MARKED UP COPY OF AMENDMENT TO SPECIFICATION

--ENGINE HALF-TROLLEY [OF SIMPLIFIED STRUCTURE] FOR
INDUSTRIAL VEHICLES--

Fig.2

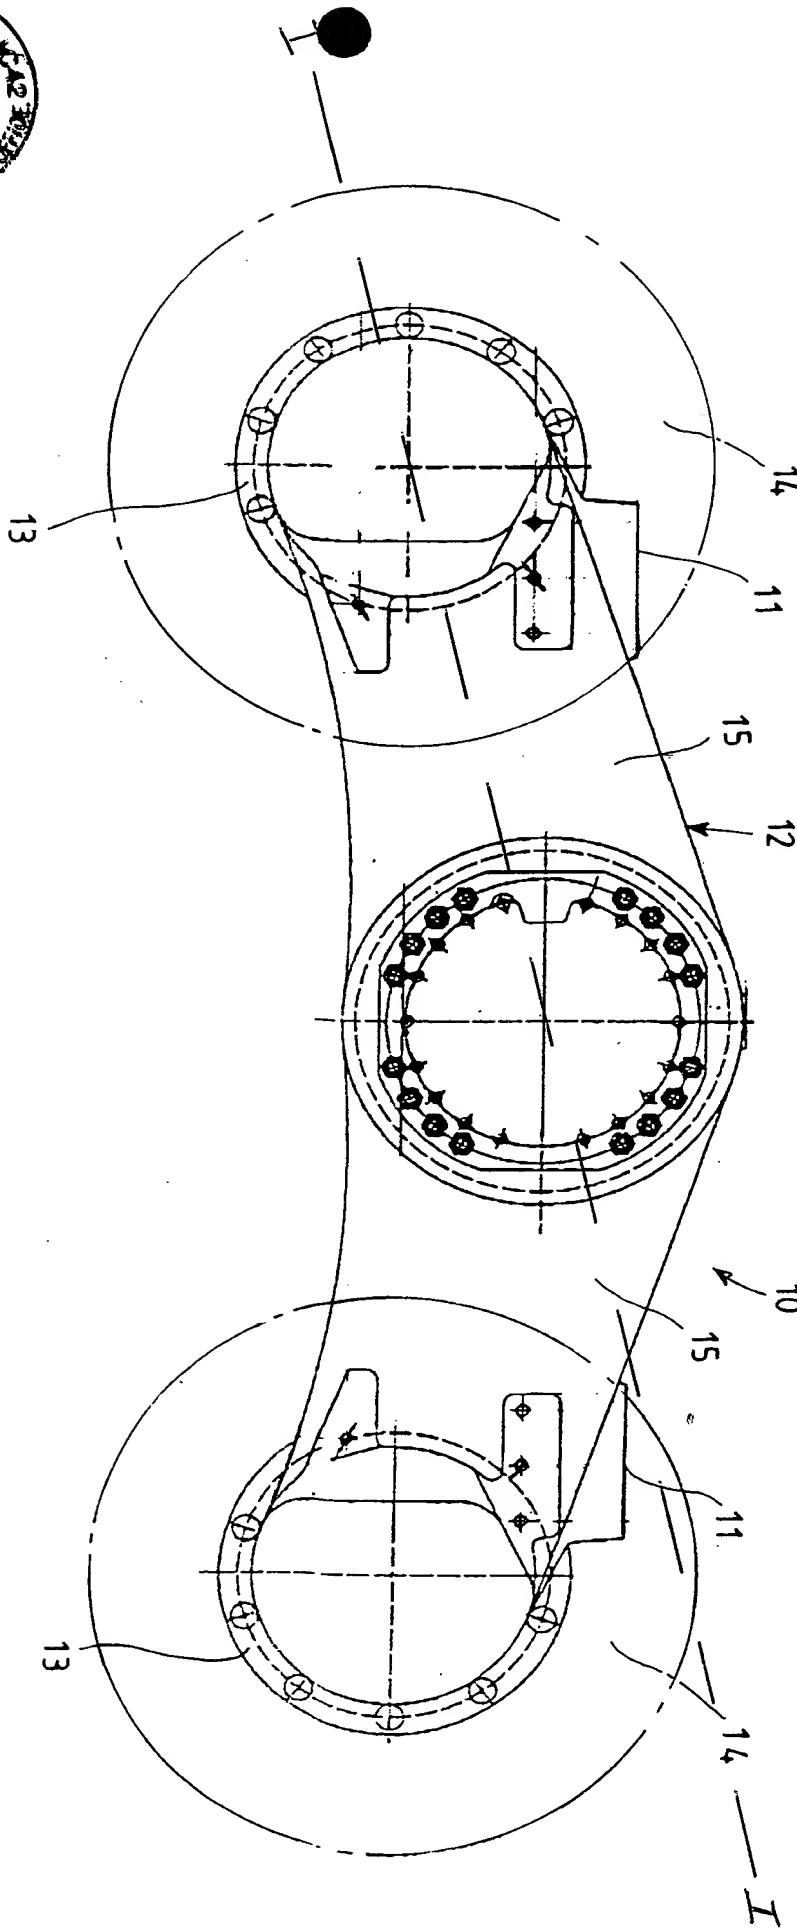
include a broken line labeled as I to show where the section was taken from which Figures 3 and 4 are based on. Additional amendments have been made to the Brief Description of the Drawings section in the specification. It is therefore requested that the objection to the drawings be withdrawn, and the drawings be considered allowable.

Figure 3 is a sectional view, at an enlarged scale, of one half of the engine half trolley illustrated in Figure 2 along the plane labeled as I according to one first embodiment; and

one half of the engine half trolley illustrated in Figure 2 along the plane labeled as I [according to the invention] in a second embodiment with inclined arms.
